TOWN OF LOS GATOS
PLANNING COMMISSION STAFF REPORT
Meeting Date: August 27, 2014

APPLICATION NO.: PD-14-003

APPLICATION SUMMARY: Requesting approval to modify the existing Planned Development (Ordinance 2147) to modify the requirement for exterior colors on property zoned HR-2½:PD. An Environmental Impact Report (EIR) was prepared for the Planned Development (Ordinance 2147) and was certified by the Town Council on December 19, 2005 and no further environmental analysis is required for this application. APNs 527-09-010 through 024 and 030 through 033.

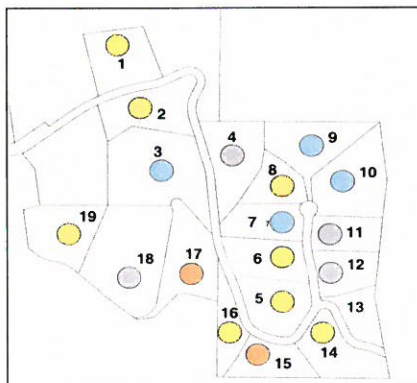
For reference, the original color scheme, the compliant color scheme, and the LRV averaged color scheme for all of the homes for which we have information are included as an appendix to this letter.

The applicant's proposal to consider the overall weighted averaging of the LRV values appears to have merit. Many of the homes will not be visible from areas outside of the immediate development neighborhood. In looking at the color studies, I find most of the wall colors which have been modified to be much too dark for good design and for their appropriateness to the individual architectural styles of the homes.

LOT 12 - ALHAMBRIAN
FRONT ELEVATION COLOR SCHEMES

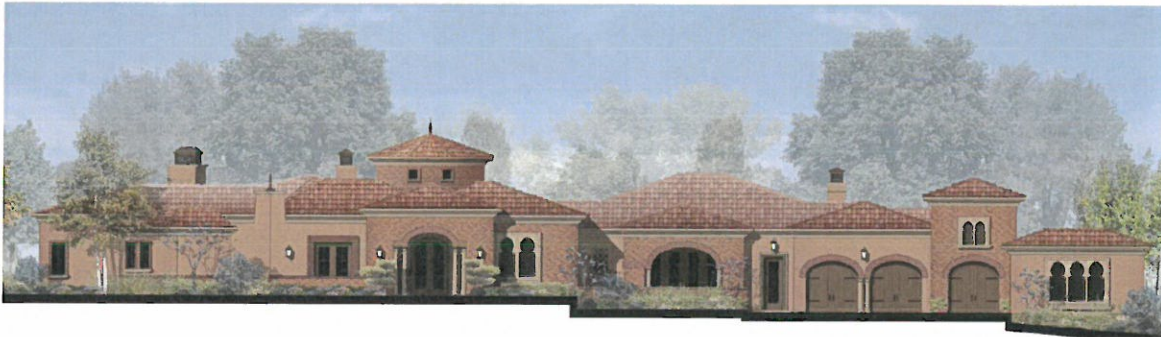
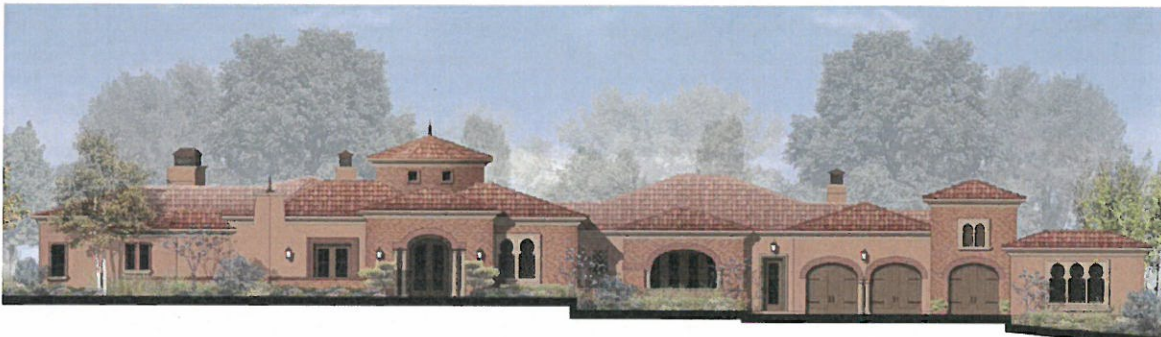
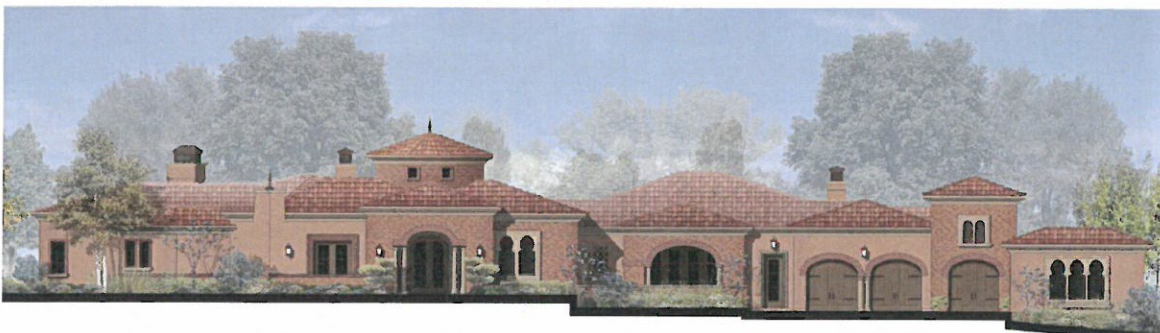
COMPLIANT (same as original)

LRV AVERAGING (same as original)
